September 6, 2018
Letter of Deficiency
DSP #18-039

RE: Vilas Pool Dam #D005006, Alstead

Dam #D005006, Vilas Pool Dam, Alstead, Inspected on 07/17/17

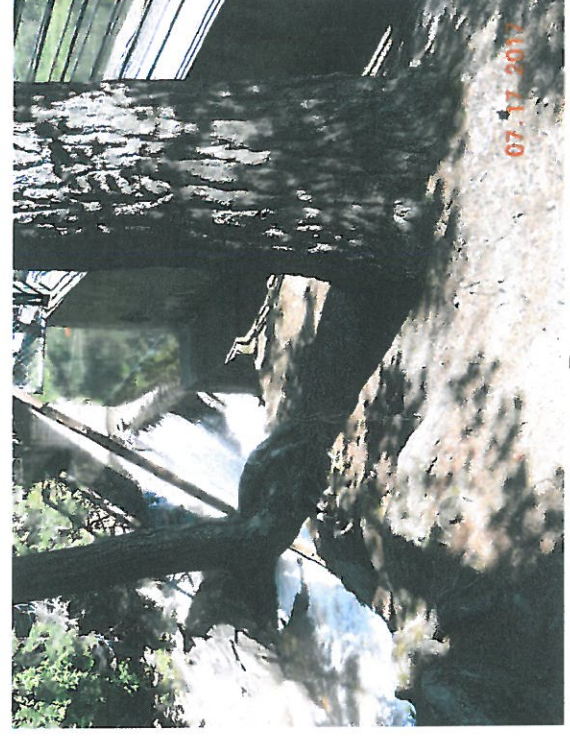
1. The crack running through the left abutment (located approximately 8 ft. left of the spillway). This crack was measured as having a $\frac{3}{4}$ " displacement. NHDES recommends installing pins to measure any movement/displacement. Notify the Dam Safety Office if any changes occur. (See photos A, B and C).

- c. The structural cracking and deterioration of concrete on the entire dam structure including, but not limited to, the following areas;
 - i. The $\frac{3}{4}$ " wide crack running through the left concrete abutment wall. (See photos A, B and C);
